**SUBJECT: ALR - Investigation of potential infill sites – [REDACTED]
and Greenway**

Overland Flow Study – Greenway Block 2 Section 28

GREENWAY – Block 2 Section 28

FEE PROPOSAL – OVERLAND FLOW STUDY

Figure 1. Blocks 2A and 2B Section 28 Greenway as shown in the LDA Brief

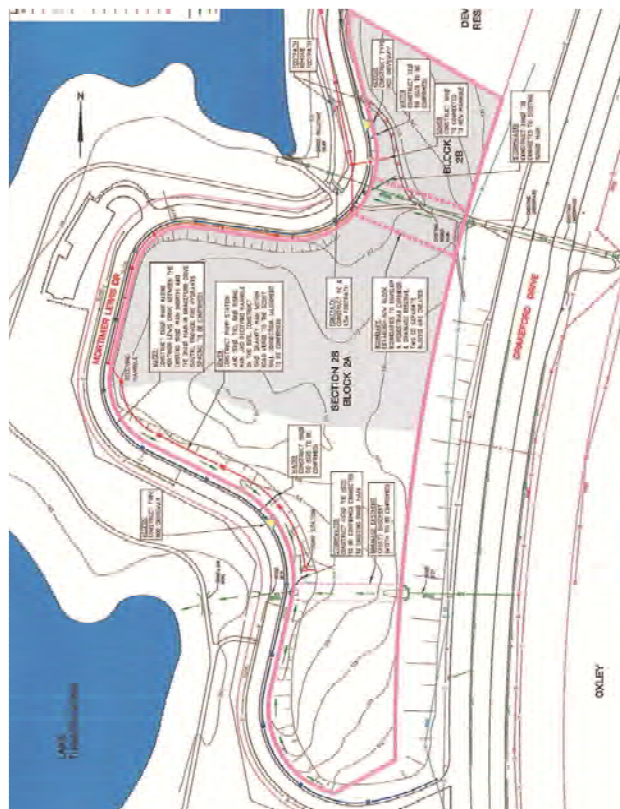
1. There is no Figure 1
2. Section 2 Catchment refers to blocks 2A and 2B – this is not shown on a figure. For your information it may be that the block is split into three blocks (as divided by the overland flow paths), can you please adjust the text to reflect this. So 2 A, B and C.
3. Please show on a figure which flow path is which OFP1 and OFP2
4. The report doesn't identify the impact on the existing footpath between 2A and 2B. Will we need a new path?
5. The conclusion refers to the option to pipe the flow with a swale on the top. Can you please include a section that clearly lists the options, with commentary on pros and cons (including impact on boundaries and hence developable land) and associated costs.

1. There is no Figure 1
 - Section 2 incorrectly referred to Figure 1 previously, should have referred to Figure 2. Figures have been changed and added in this version
2. Section 2 Catchment refers to blocks 2A and 2B – this is not shown on a figure. For your information it may be that the block is split into three blocks (as divided by the overland flow paths), can you please adjust the text to reflect this. So 2 A, B and C.
 - LDA Brief showed 2A and 2B. We have now included the figure from LDA Brief - Figure 1.

Figure 2. Overland Flow Paths OFP1 and OFP2 (aerial image sourced from ACTmap)

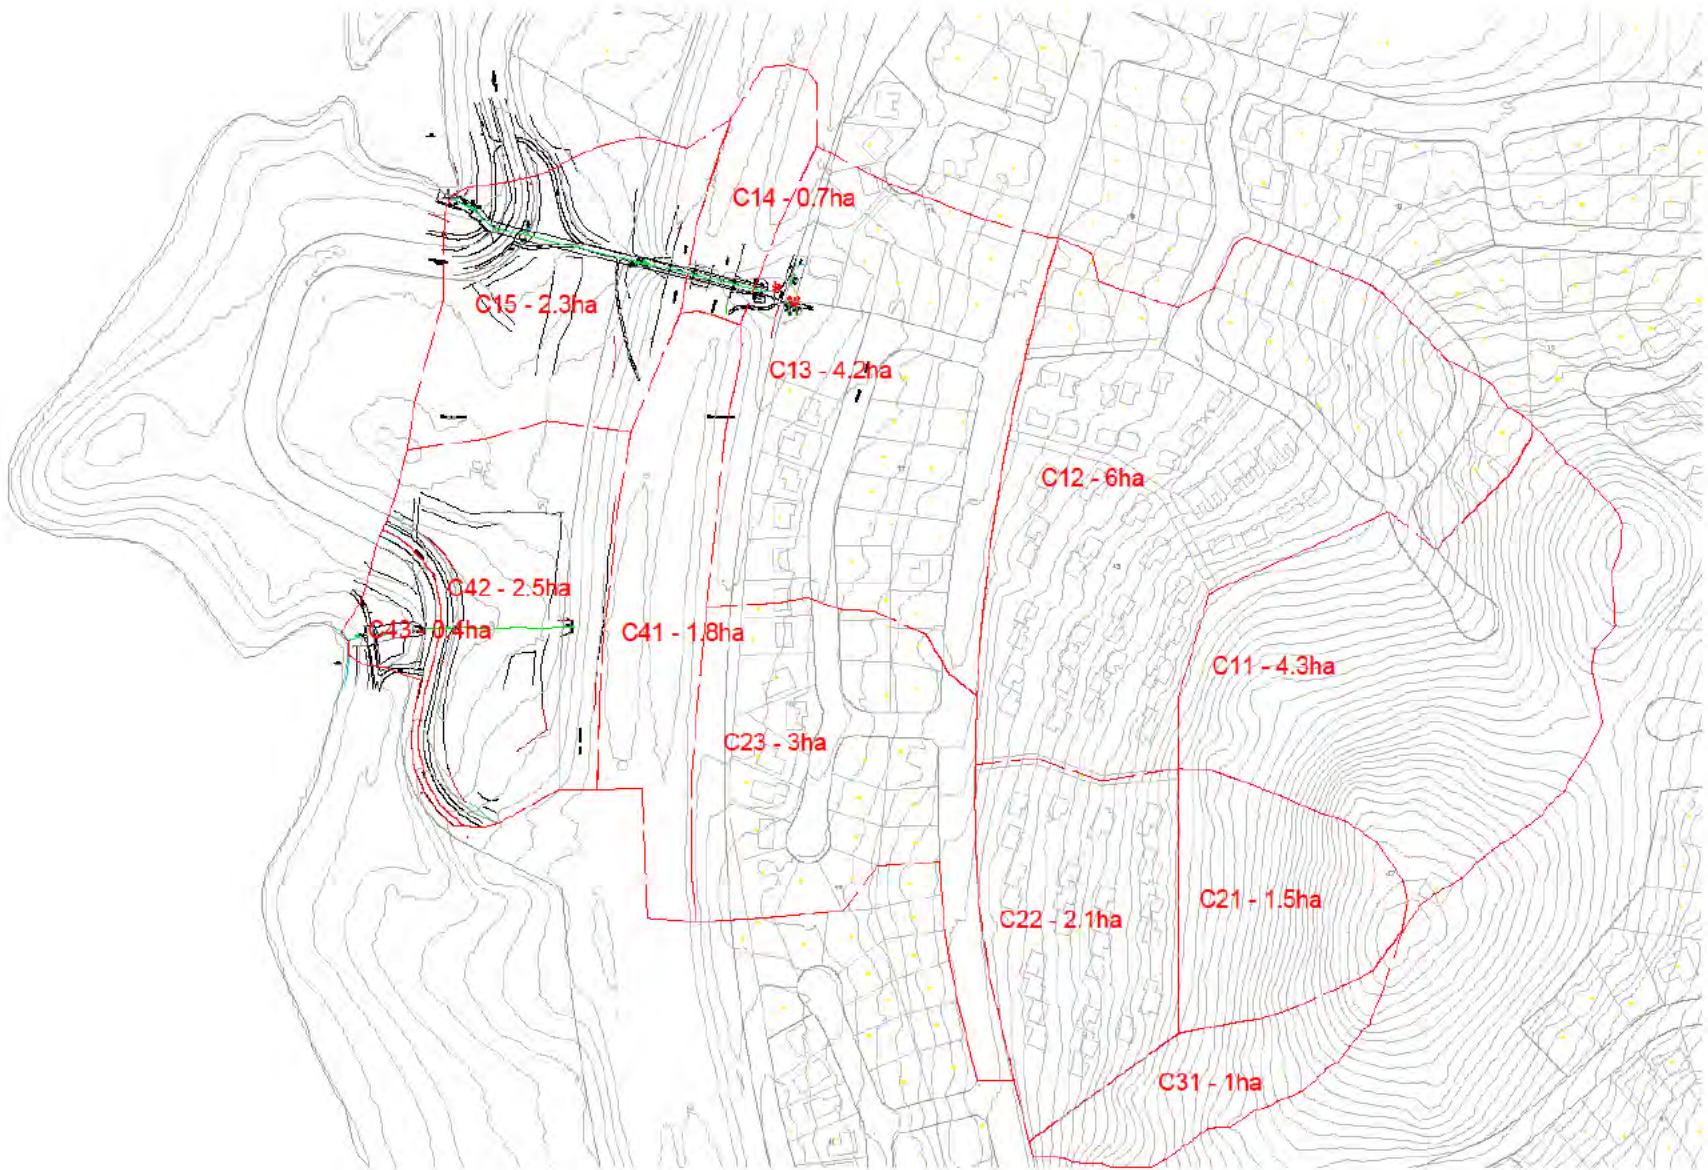
3. Please show on a figure which flow path is which OFP1 and OFP2
 - Figure 2 now shows OFP1 and OFP2
4. The report doesn't identify the impact on the existing footpath between 2A and 2B. Will we need a new path?

Figure 6. Sketches showing channel/swale typical cross-sections
 (a) Concrete Channel, (b) Grassed Channel, and (c) Pipe and Swale
 Note: Sketches are not to scale and are for illustration only

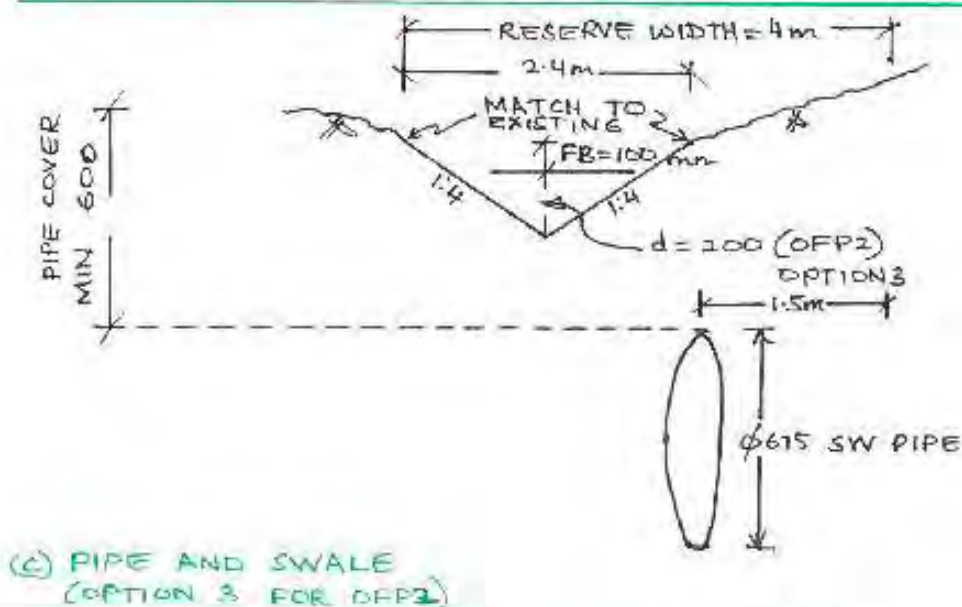
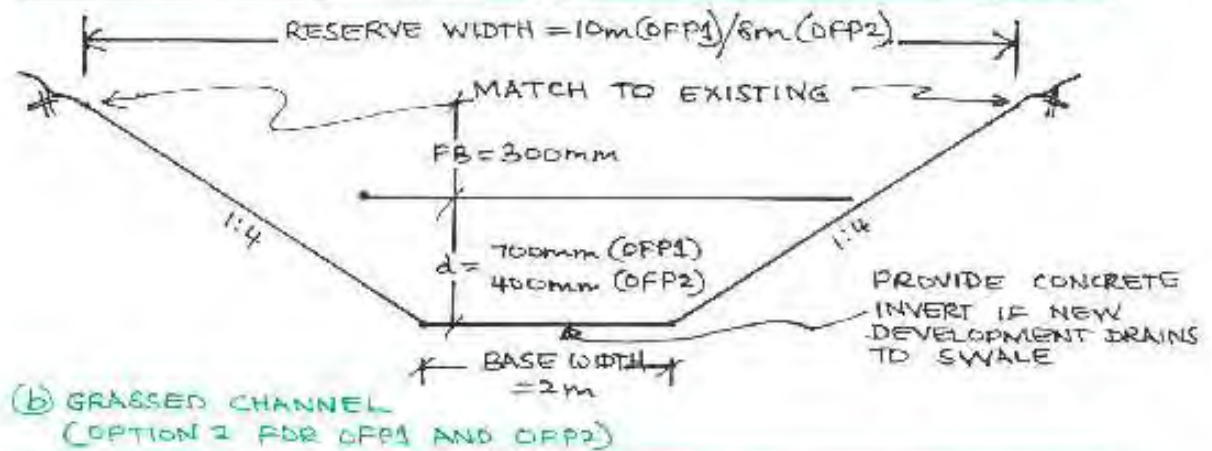
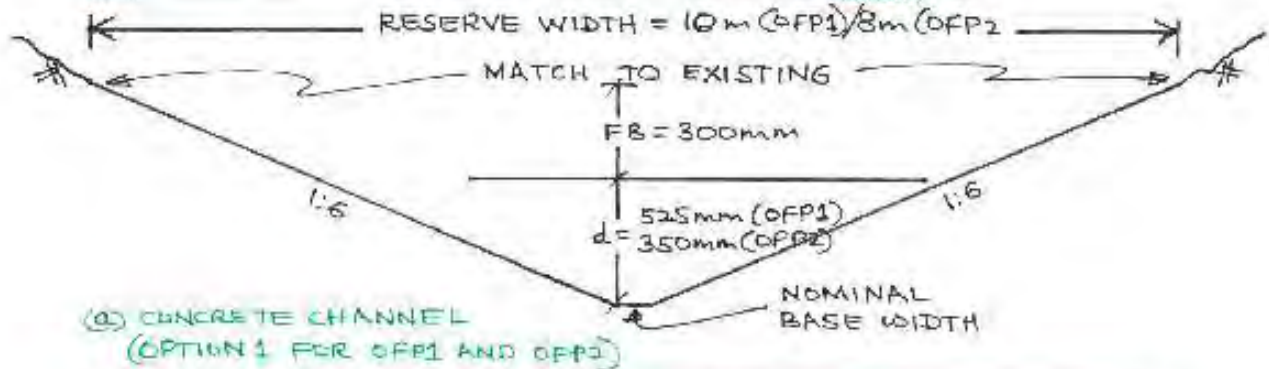
- Under Section 6 Flood Impacts, we now have a brief discussion on impact on footpath, making it clear that a new path will not be required
5. The conclusion refers to the option to pipe the flow with a swale on the top. Can you please include a section that clearly lists the options, with commentary on pros and cons (including impact on boundaries and hence developable land) and associated costs.

- Under Section 7 Flood Protection Measures, we have now listed the different options for flood protection for the two paths separately. We have also included hand-drawn sketches to illustrate the options. Advantages of one over the other are also noted.
